# Near-term Task Force Recommendation 2.1 Seismic Hazard Evaluation

# **NTTF Recommendation 2.1- Summary of Preliminary Seismic Hazard Analysis: Indian Point Units 2 and 3**

# Indian Point 2

# Indian Point 3

## Summary of Issues

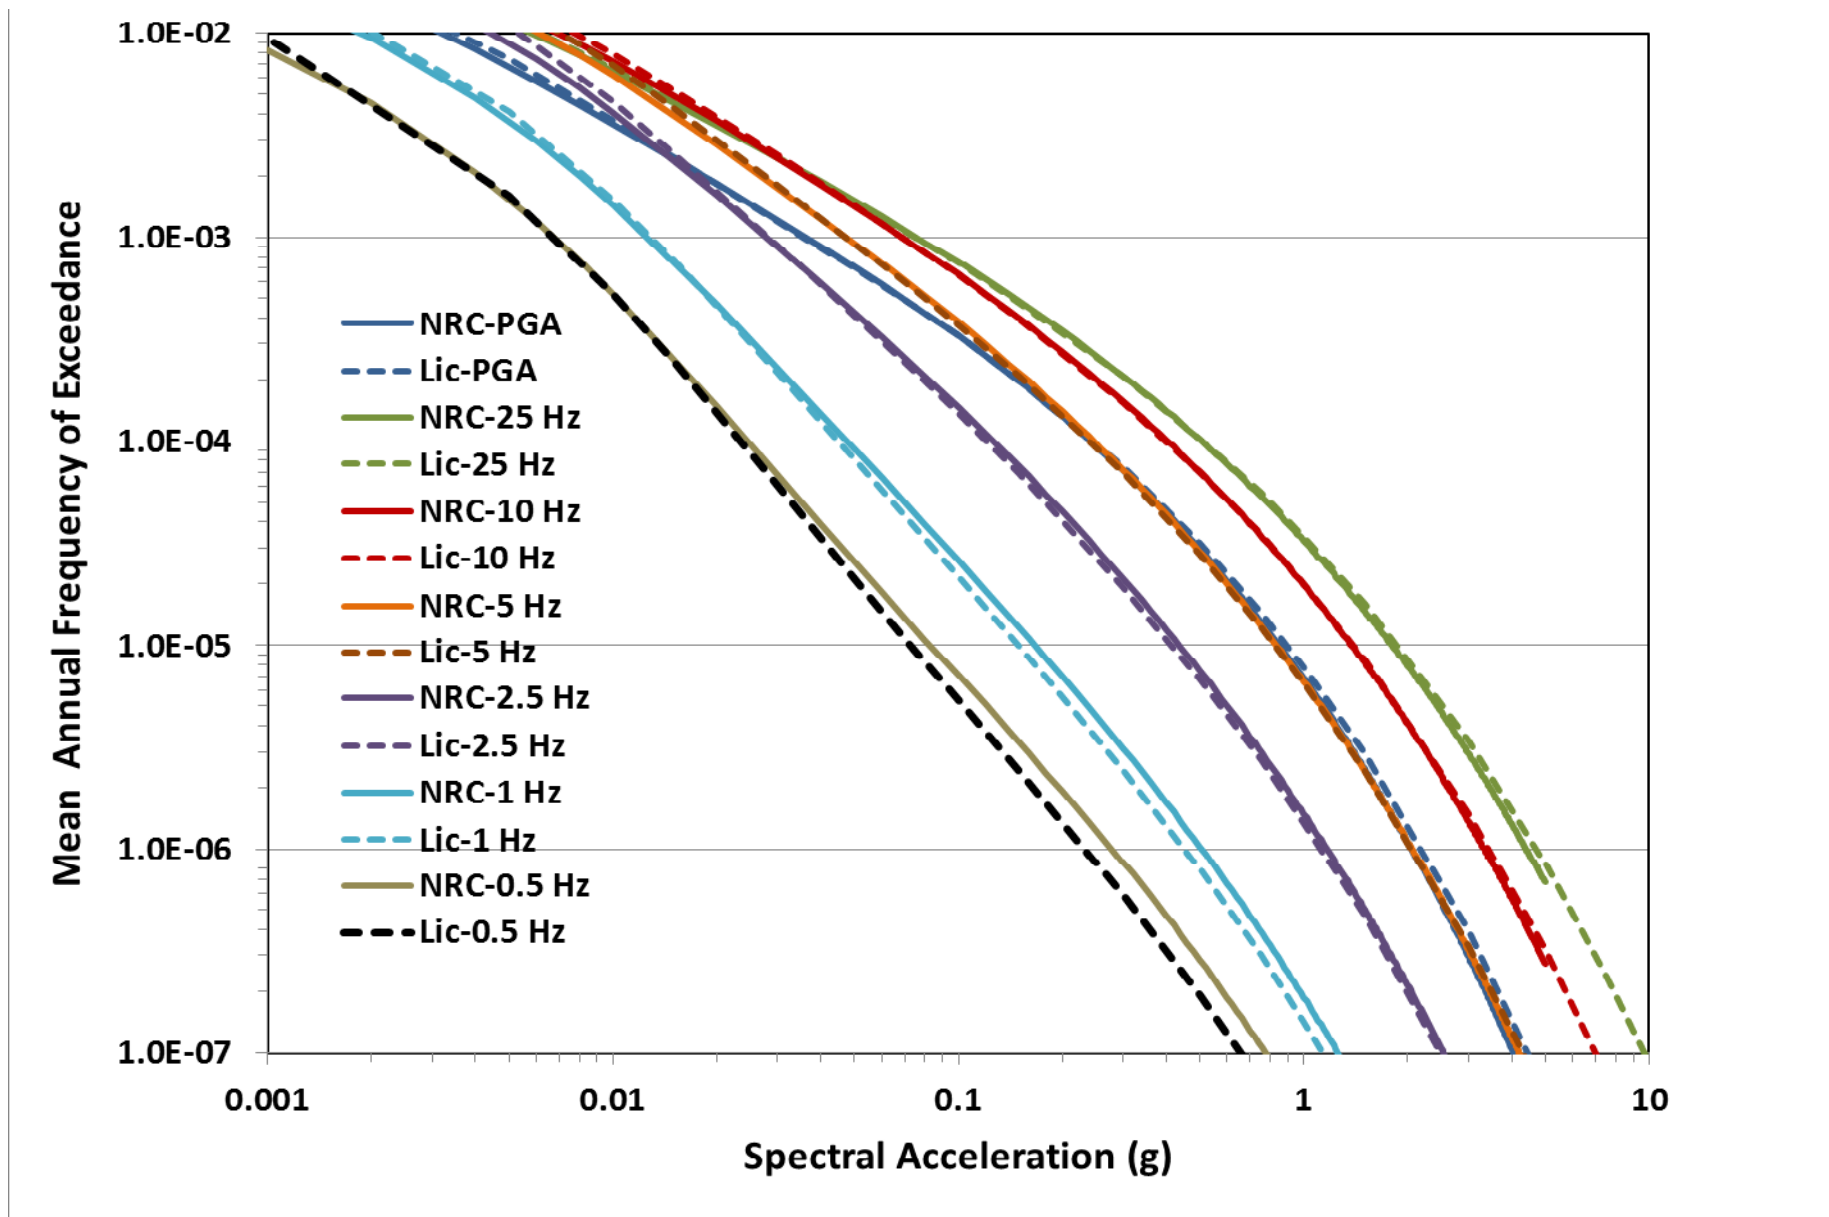
- Licensee did not perform site response analysis. Cited P-wave refraction profile as justification
- NRC Staff used available on-site data and performed a site response analysis
- NRC staff concludes both Units ***screen-in*** for all risk evaluation activities
  - Difference due to site response, not rock hazard
- Additional information on plant-level capacity was included in IP3 submittal.
  - Used to support Section 5 Interim Actions of March Seismic Hazard and Screening Report submittal

<b>SHEAR WAVE VELOCITY PROFILE</b> ReMi RESULTS INDIAN POINT POWER PLANT	
	LOCATION: BUCHANAN, NEW YORK	
PROJECT #: 06-245-1	CLIENT: GZA GEOENVIRONMENTAL	FIGURE 8A
DATE: SEPTEMBER 20, 2006	DATE: 8/11/06	DRAWN BY: B. MILLER

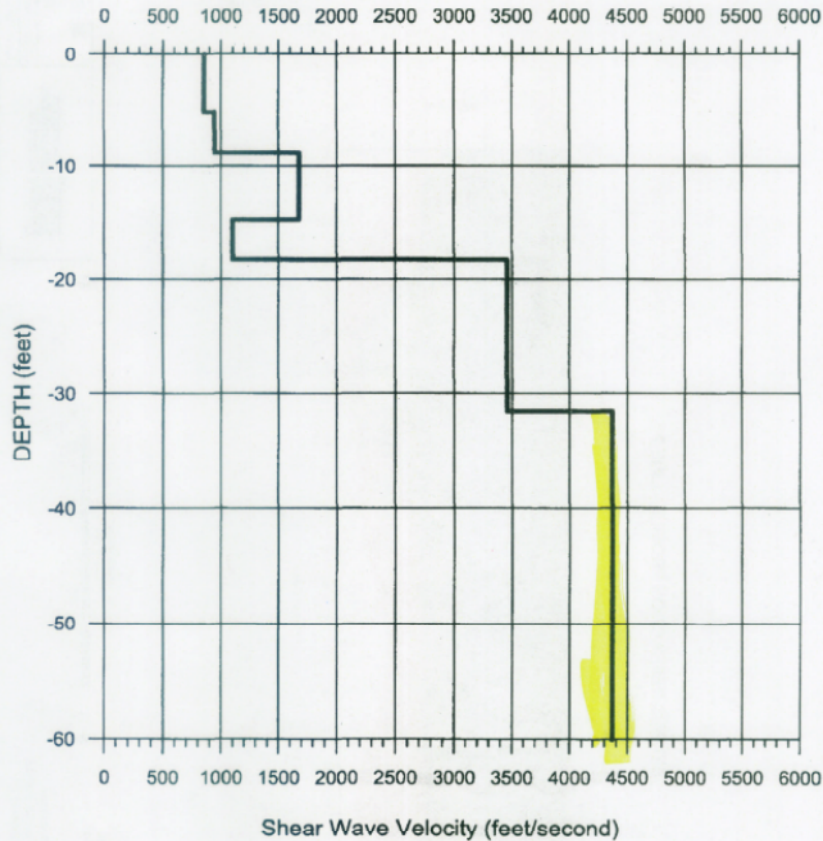
Shear-wave velocity profile from IP site.

13 profiles acquired with Surface wave-technique- All penetrated bedrock

Very consistent velocities in upper portion of bedrock (Inwood)

# GZA Report: Seismic Profiles

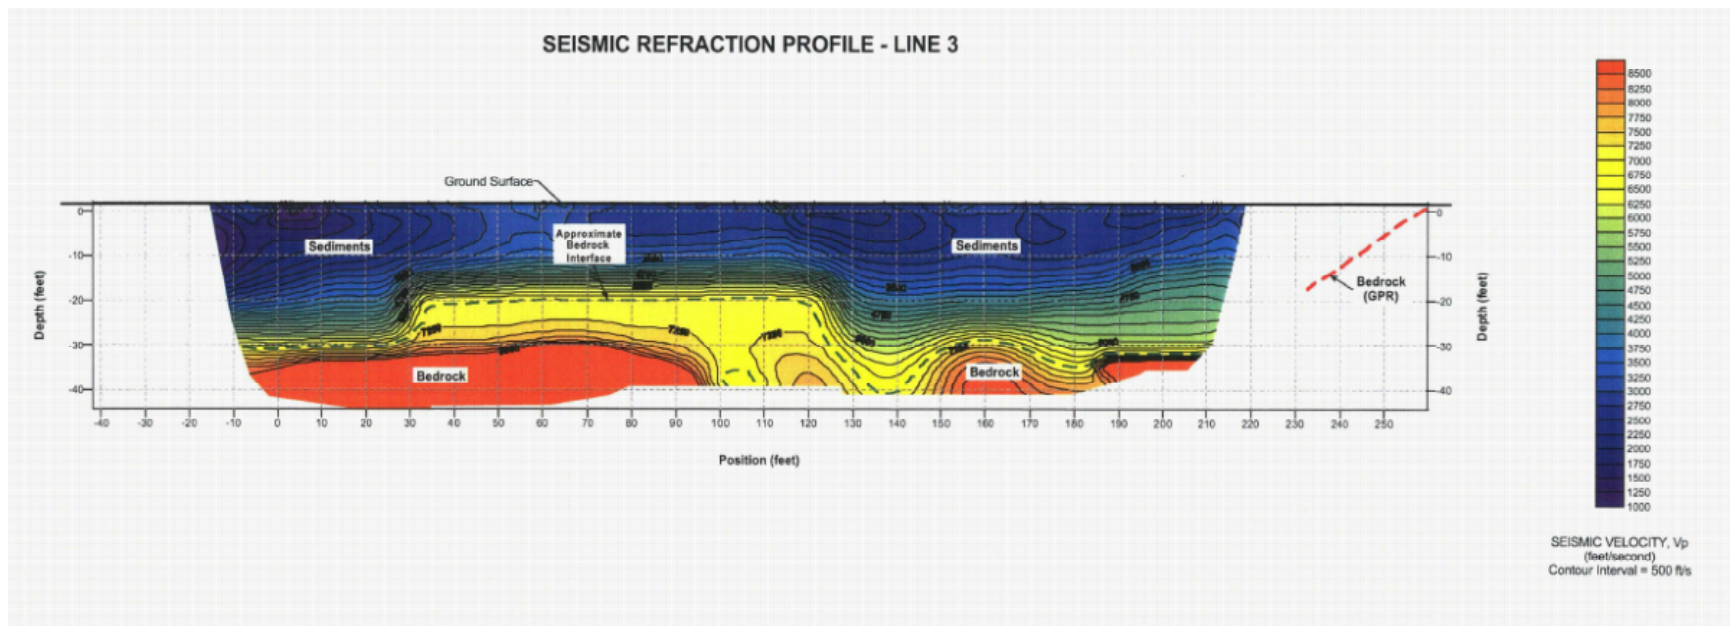
Independent P-wave data indicates  $V_p \sim 8-9000$  fps in near surface.

## Amplification Functions: Indian Point Site

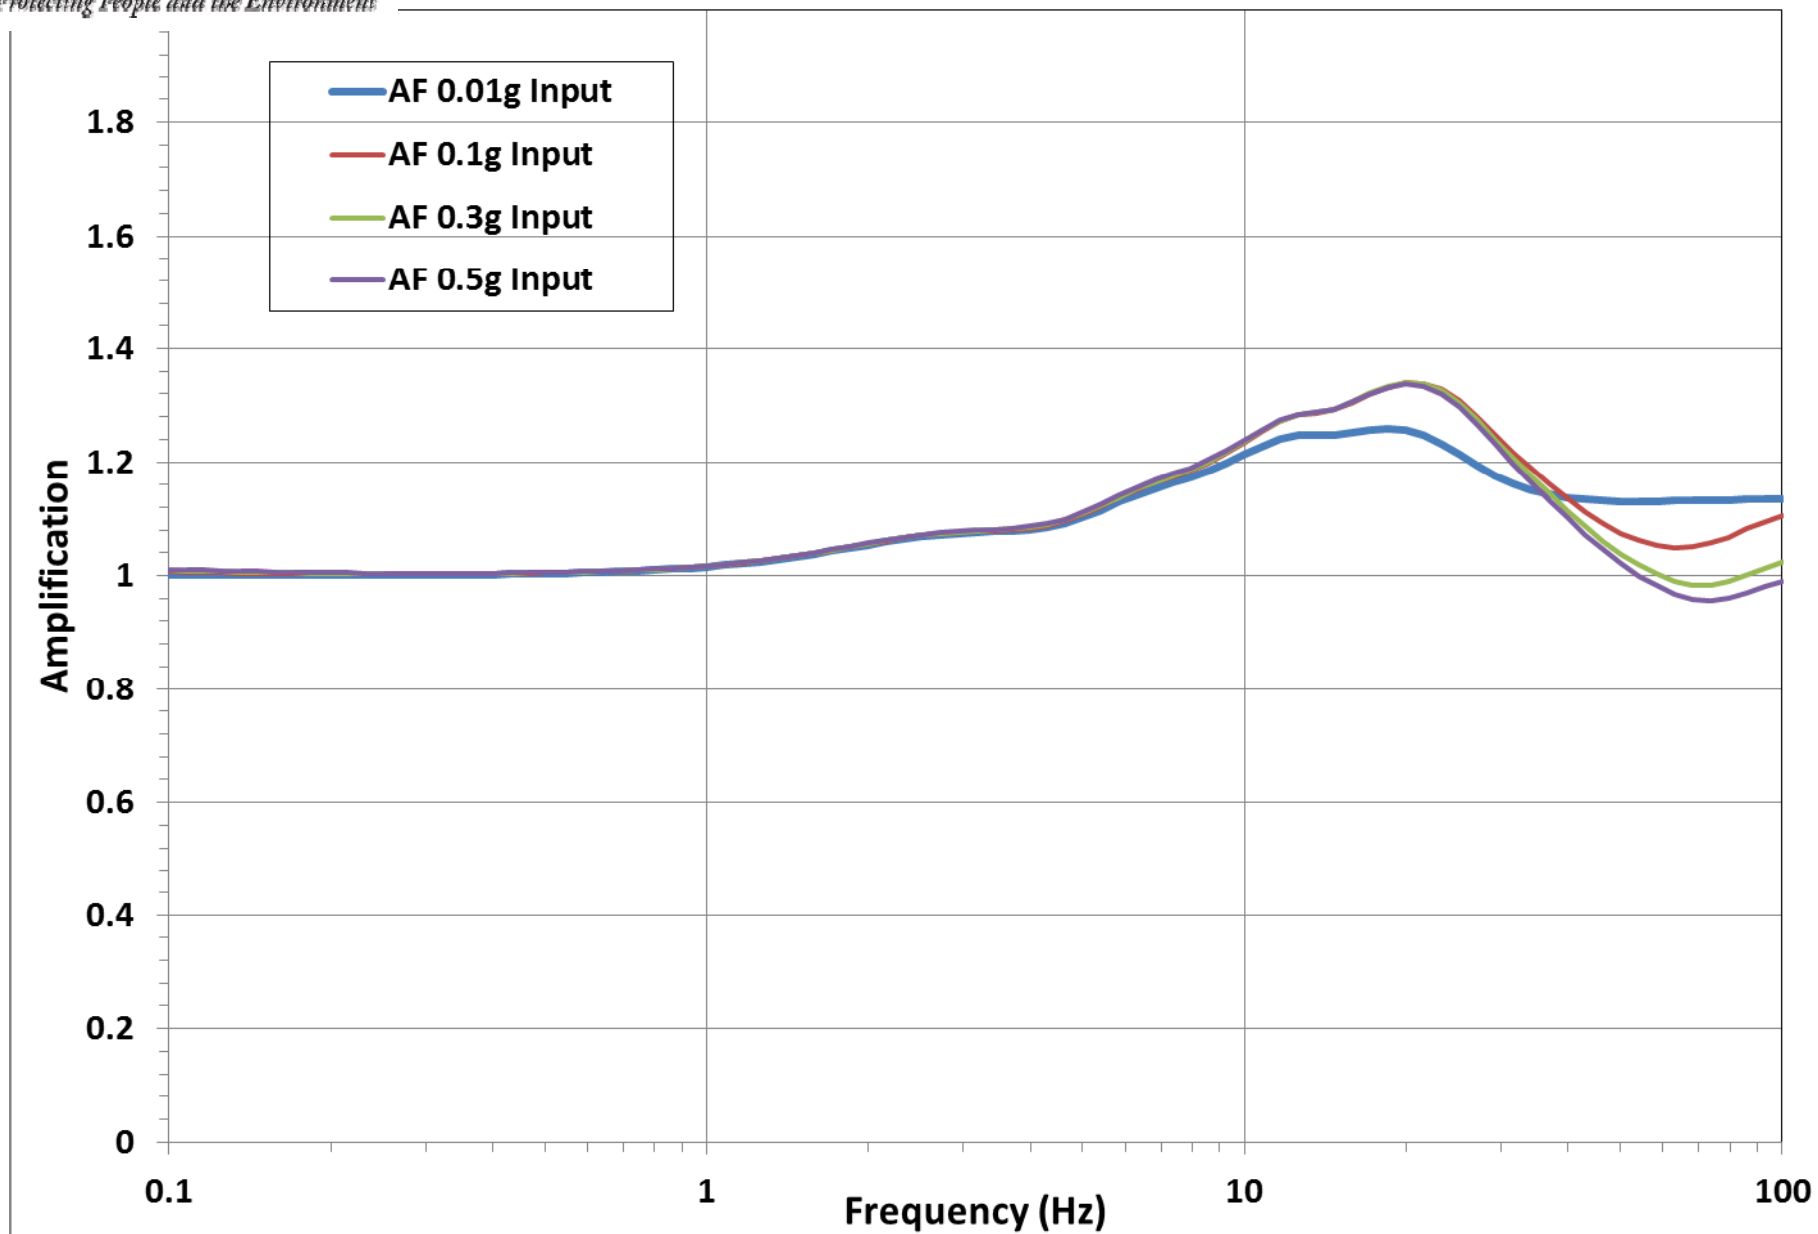
Layer	Depth (ft)	Velocity (ft/s)	Sigma-In (Vs)	G/Gmax&D	G/Gmax&D
BC-1	0-40	4900	0.15	EPRI Rock	Linear-1%
BC-2	40-75	6419	0.15	EPRI Rock	Linear-1%
BC-3	75-100	8024	0.15	EPRI Rock	Linear-1%
BC-4	100-200	8400	0.15	Linear-ND	Linear-ND
LBC-1	0-40	4320	0.15	EPRI Rock	Linear-1%
LBC-2	40-100	5662	0.15	EPRI Rock	Linear-1%
LBC-3	100-200	7077	0.15	EPRI Rock	Linear-1%
LBC-3	200-400	7785	0.15	Linear-ND	Linear-ND
LBC-4	400-800	8500	0.15	Linear-ND	Linear-ND
UBC-1	0-40	5555	0.15	EPRI Rock	Linear-1%
UBC-2	40-75	7277	0.15	EPRI Rock	Linear-1%
UBC-3	75-85	9000	0.10	EPRI Rock	Linear-1%

## Spectral Comparison: Indian Point Site

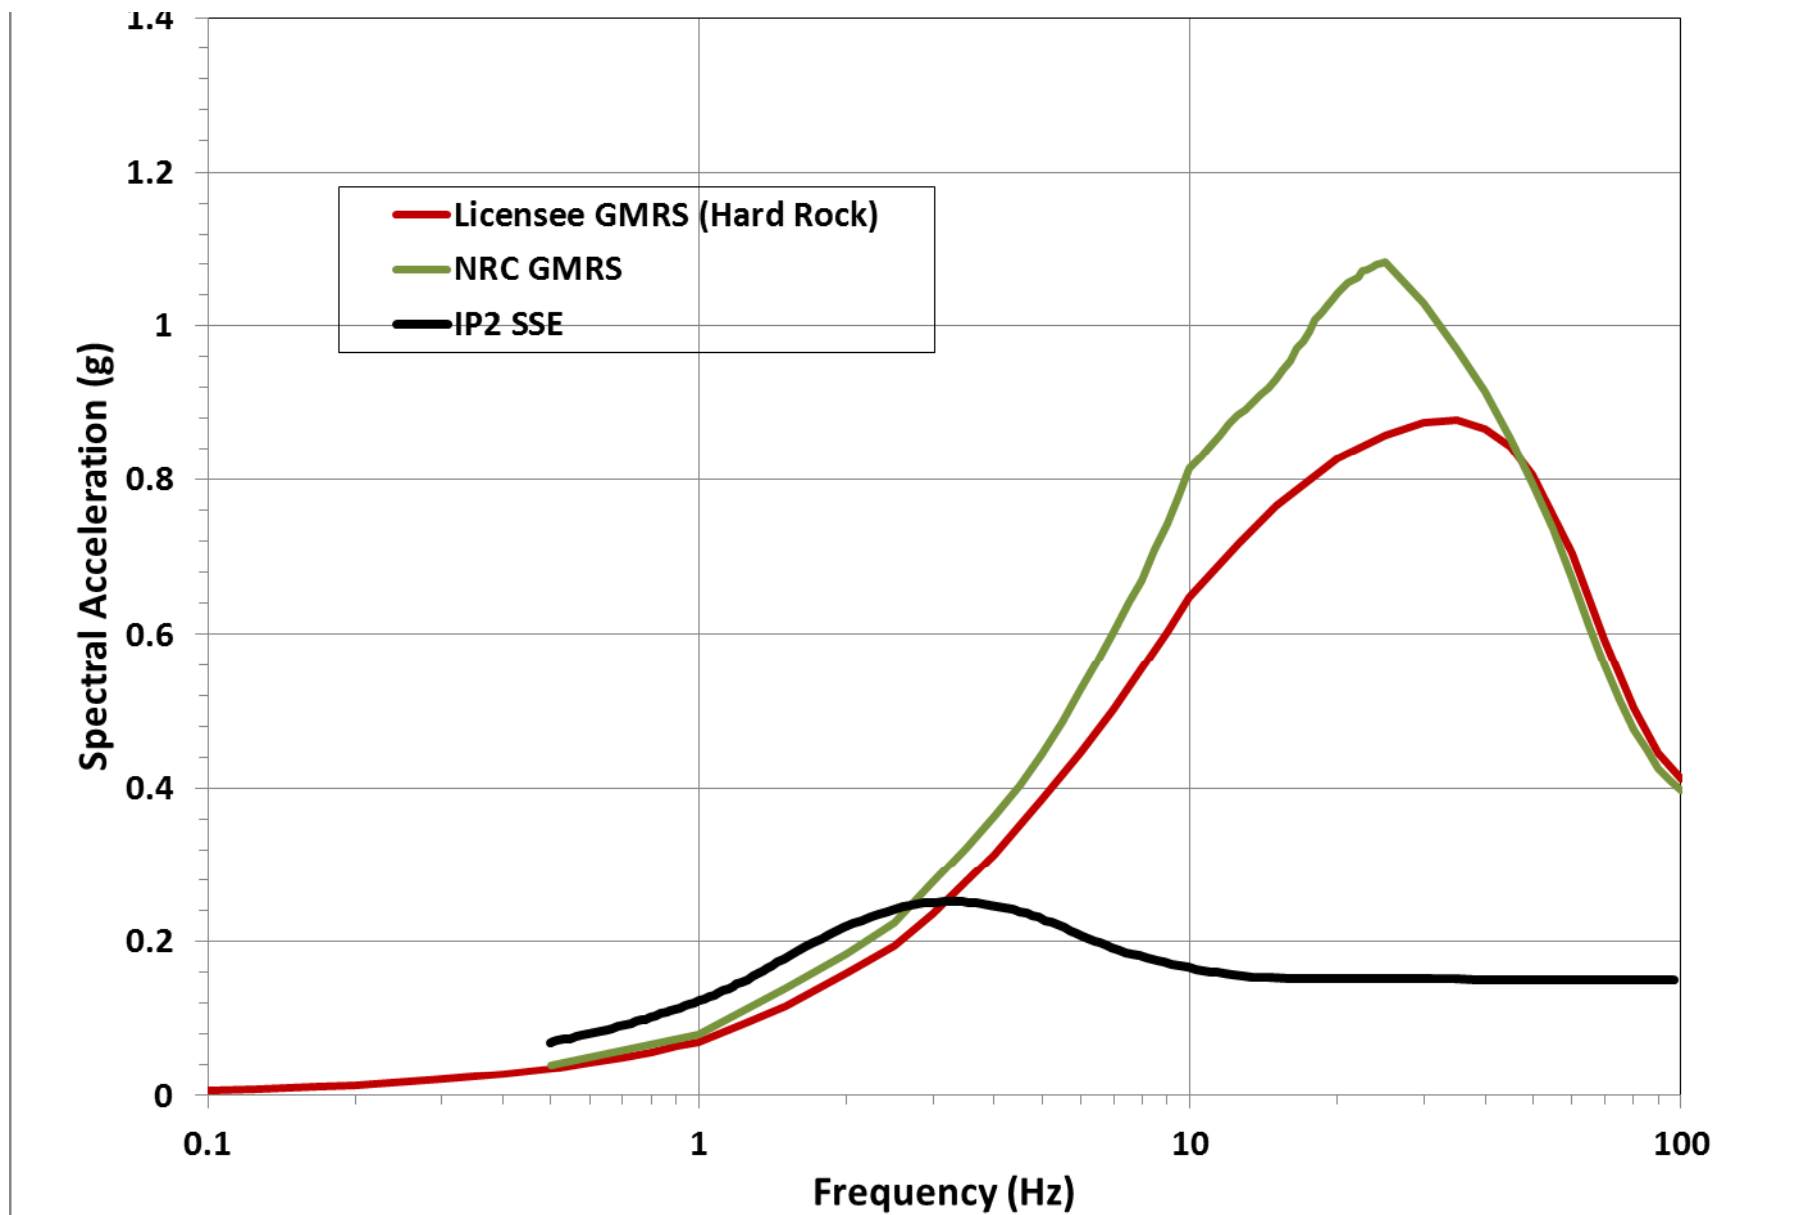
- Licensee did not perform site response analysis. Cited P-wave refraction profile as justification
- NRC Staff used available on-site data and performed a site response analysis
- NRC staff concludes both Units ***screen-in*** for all risk evaluation activities
  - Difference due to site response, not rock hazard
- Additional information on plant-level capacity was included in IP3 submittal.
  - Used to support Section 5 Interim Actions of March Seismic Hazard and Screening Report submittal
